20141215-5010 FERC PDF (Unofficial) 12/13/2014 5:40:17 PM

**IND59 Michael Young, The Dalles, OR**

**Description of full-containment LNG tanks**

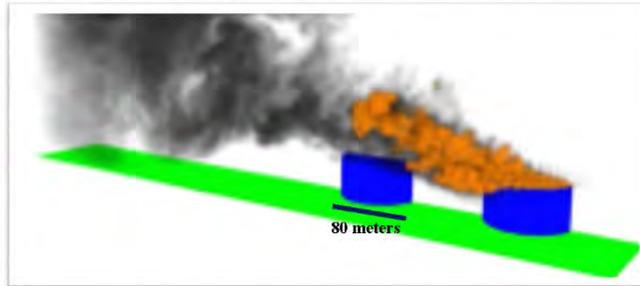
- Very large – 80 > 90 meters diameter, 40 > 50 meters tall
- Post tensioned reinforced concrete, walls 0.7 m thick, roof 0.5 m thick
- Post tension; steel, vertical and circumferential through buttresses and tendons
- Concrete shell outer layer, inner layers, vapor barrier (steel), insulation (perlite) Nickel-steel LNG containment
- Plumbing, in and out, through the tank top

LNG tank-top fire (high wind speed) FDS model results by Venart

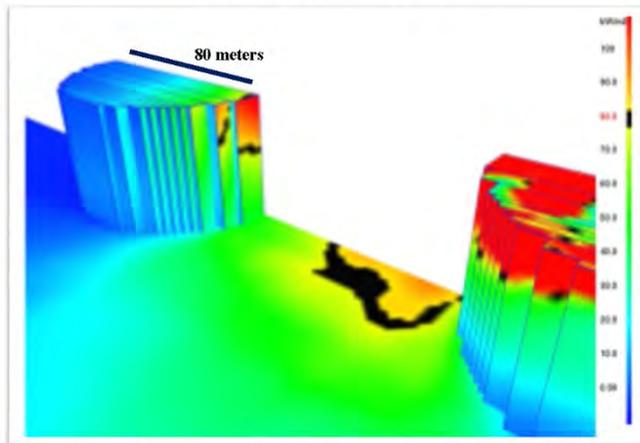
Down-wind tank being exposed to an up-wind tank-top fire  
Boundary heat flux for two tanks at 1 minute after fire initiation.  
Incident heat flux exposures to both tanks in excess of 80 kW/m<sup>2</sup>, wind 7.5 m/s.

Figure 4.13-1 from DEIS  
Vapor Fences at Jordan Cove Facility

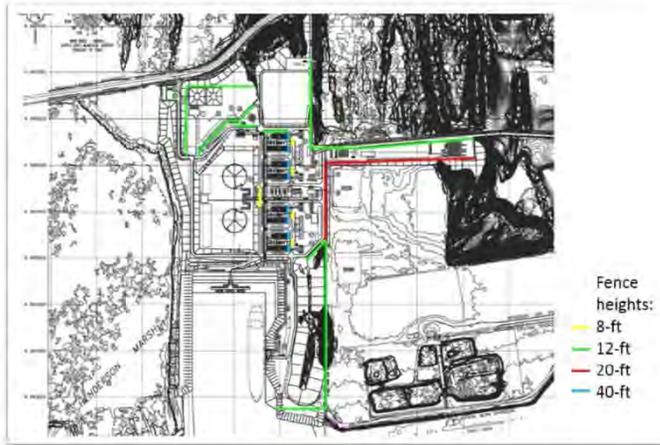
The vapor dispersion distances calculated using PHAST and FLACS, while extending in some cases slightly past the applicant’s property boundaries, obviously could not have been determined by the (dispersion) models used without the applicant’s provision of gas-impermeable vapor fences to retain the flammable cloud boundaries within the property boundary. The Figure below indicates the position of the proposed vapor fences; gas-impermeable concrete fences as tall as forty feet.
